D3FE (All American) Radiator Cap Relocation

Photo #2 Photo #3

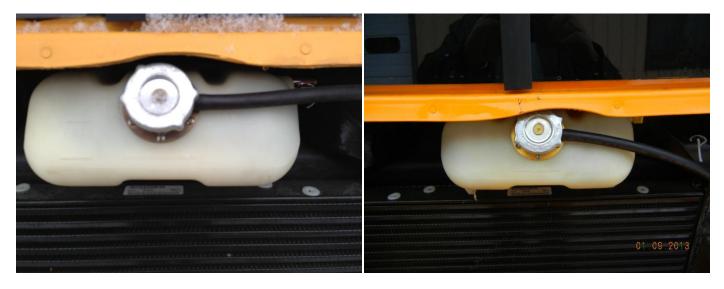
- #1 Open the engine hood to reveal coolant tank (Photo #2 & #3) This will work with earlier style hoods which lift out and up as well and the newer style which open out and down

- #2 As you can see by the first 2 photos, on some units the radiator cap is actually partially covered by the lower windshield frame The filler neck is smaller in diameter than the radiator cap and will fit even when it seems to close but in some instances you may need to reposition the coolant tank slightly to gain clearance.

Photo #4 Photo #5

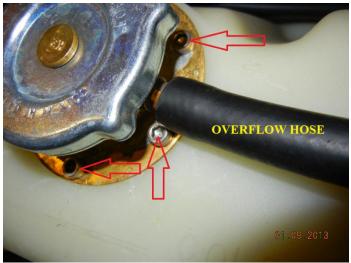
- #3 Remove the overflow hose from the neck (Photo #4).
- #4 Next use either a 3/32"(earlier models) or a 9/64" hex wrench (Photo#6) to remove the 6 screws holding the neck to the tank (Photos #3 & #4)
